**PLANNED UNIT DEVELOPMENT
& SUBDIVISION STAFF REPORT**

DEVELOPMENT NAME Dobbs Industrial Park Subdivision, First Addition, Resubdivision of Lots 1 & 2

LOCATION 3730 Halls Mill Road
(North side of Halls Mill Road, 130'± West of Varner Drive)

CONTEMPLATED USE Planned Unit Development Approval to allow shared access and parking between two building sites.

SITE PLAN

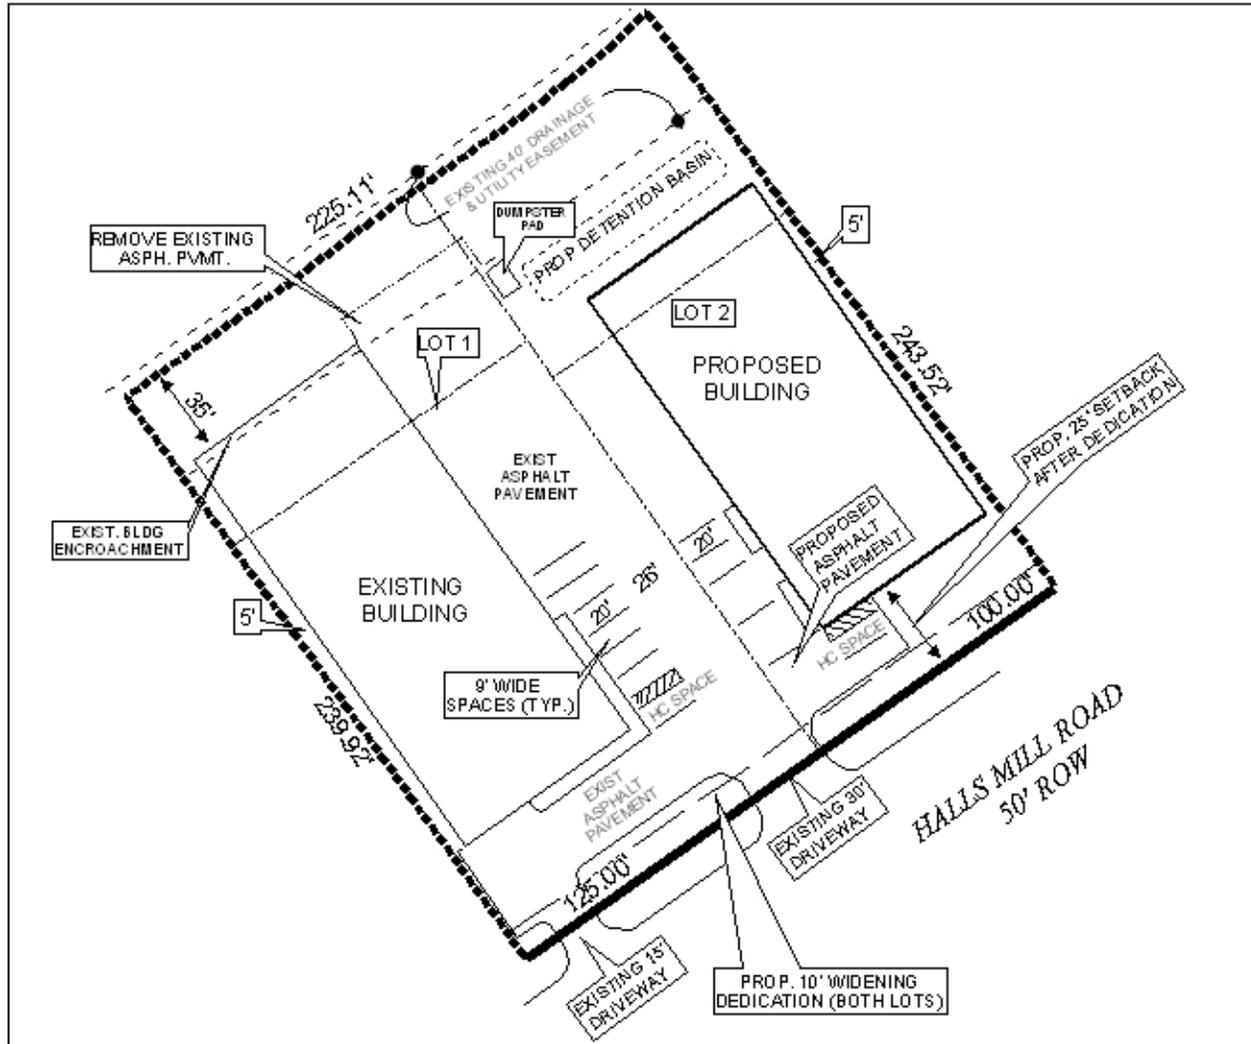
Regarding the PUD, the site plan submitted indicates an existing sheet metal and guttering fabrication building on Lot 1, and a similar light industrial use building proposed for Lot 2. No narrative was submitted giving a detailed description of use for the proposed building or time table for expansion. The site plan submitted indicates all property line setbacks to be compliant after frontage dedication, and site coverage is determined to be compliant. There is, however, an approximate 4' encroachment of the rear of the existing building into a recorded 40' drainage easement, 35' of which is on this site. This encroachment is proposed to remain. The site plan approved for the construction of the building on Lot 1 indicated a 37' setback from the rear property line to the rear of the building. Since the Commission cannot approve a site plan indicating an encroachment into a recorded easement, this encroachment must be resolved.

The site plan does not indicate a dumpster location, but the engineer's narrative indicates that it is planned on the Eastern lot in the area close to the detention facility. It is stated that an exact location will be determined based on topographic and storm drainage considerations.

As the site plan indicates both of the existing drives are to remain unchanged, and since Traffic Engineering has recommended the closure of the 15' wide drive and the reconfiguration of the 30' wide drive, there may be a significant impact on the proposed traffic circulation on site, especially when considering truck loading/unloading and maneuvering areas.

Each lot is proposed to meet the total landscaping area requirement. Lot 1 was developed in 1999 and should have been subject to the landscaping and tree planting requirements. It should be noted that Lot 1 was developed with the required frontage over-story trees, but those trees have been removed and not replaced. However, it was not developed in compliance with the frontage landscaping area requirements. With the required frontage dedication, Lot 1 will lose further frontage landscaping area. Since both lots are proposed to be developed as a PUD, the frontage landscaping on Lot 2 could be increased to make up the lacking difference. But calculations provided with the application indicate a total site frontage landscaping area shortage of approximately 2,100 square feet. With the recorded 40' drainage easement along the North end of the site, and the proposed detention facility between it and the North end of the proposed building on Lot 2, and the required 10' dedication along Halls Mill Road, the buildable site depth is compressed. But new development should account for the current site compliance requirements. Even though it is below the 75% allowable site coverage, the proposed building on Lot 2 appears to be too large when the site constraints are considered. Therefore, the site plan should be revised to accommodate the required site frontage landscaping, especially when considering the property directly across Halls Mill Road is zoned R-1, Single-Family Residential. Since abutting zonings are also I-1, no perimeter buffer requirements would apply.

Given the deficiencies in the site plan with regard to dumpster location and the frontage landscaping shortage, the fact that Traffic Engineering has recommended significant changes to the site's access, and the building encroachment into the recorded drainage easement; this application should be heldover to allow the applicant to address these issues.

- 1) illustration of the dumpster location on the site plan;
- 2) revision of the site plan to indicate the closure of the 15' drive and the modification of the 30' drive to either a 36' wide three-lane drive or a 24' wide two-lane drive;
- 3) revision of the site plan to provide the required frontage landscaping area and required seven over-story frontage trees; and
- 4) resolution of the building encroachment on Lot 1 into the recorded drainage easement.

Planned Unit Development: Based on the preceding, this application is recommended for denial since no revised site plan has been submitted to address the following:

- 1) illustration of the dumpster location on the site plan;
- 2) revision of the site plan to indicate the closure of the 15' drive and the modification of the 30' drive to either a 36' wide three-lane drive or a 24' wide two-lane drive; and
- 3) revision of the site plan to provide the required frontage landscaping area and required seven over-story frontage trees.
